Subject: **ACTION**: Review and Concurrence, Equivalent Level of
Safety Finding for Cessna New Model 680; Thrust
Reversers
FAA Project #TC2548WI-T

Date: July 12, 2004

ELOS Memo #: TC2548WI-T-P-6

Thrust Reverser Overstow Envelope

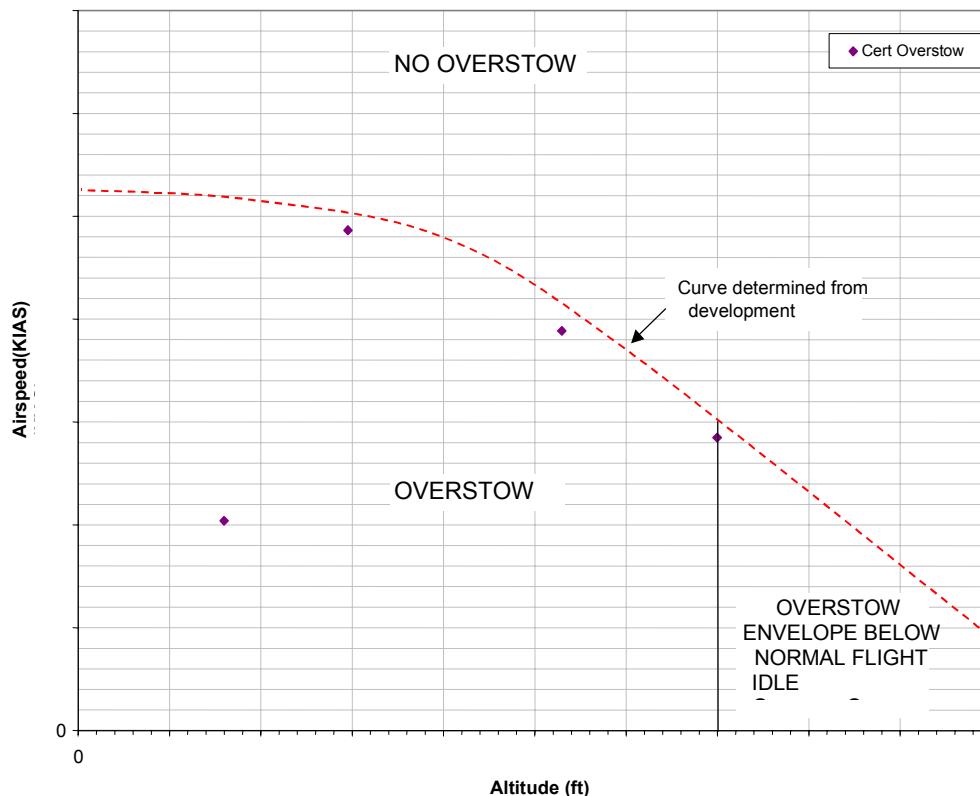
The T/R primary actuator has been sized such that at thrust settings greater than idle or airspeed above a given amount (defined as the overstow airspeed), the pressure on the inside of the T/R doors or the negative aerodynamic pressure on the outside of the T/R doors, or a combination of both is greater than the actuator can overcome, preventing the overstow requirement needed for unlatch and deployment of the doors. Flight test has defined the overstow envelope for the aircraft. If the airspeed is above this envelope, the T/R cannot deploy. Therefore, barring multiple structural failures in the door latch mechanism, the only possible position of the T/R, even if commanded to deploy, is stowed. Flight testing has shown that there are even thrust setting and aircraft speed combinations within the overstow envelope where the T/R cannot deploy.

In addition to the overstow envelope defining where the T/R could deploy with the engine at idle, if the engine speed is above approximately 60% N1, the nozzle pressure is high enough at all airspeeds to prevent the T/R overstow motion and this also prevents the T/R from being able to deploy. Therefore at all airspeeds when the engine speed is above 60% N1, barring multiple structural failures within the door latch mechanism, the only possible position of the T/R is stowed. This provides an additional level of protection for the aircraft during the takeoff phase of flight. The significance of the overstow envelope is that for a T/R to deploy above the overstow envelope would require failure of multiple critical T/R structural components, which is entirely independent of system failures. The portions of the Model 680 Mission Profile where the aircraft might be in the overstow envelope are limited to Approach, and Landing. Compliance was demonstrated for deployments within this overstow envelope.

The Model 680 is capable of safe flight and landing with a T/R deployed within the overstop envelope shown above, thus providing direct compliance with § 25.933(a)(1)(ii) for that part of the flight envelope. Acceptable compensating factors that support an equivalent level of safety to § 25.933(a)(1)(ii) have been established for the Model 680 when the airplane is the operating outside the overstop envelope (i.e. within the no overstop envelope) as follows:
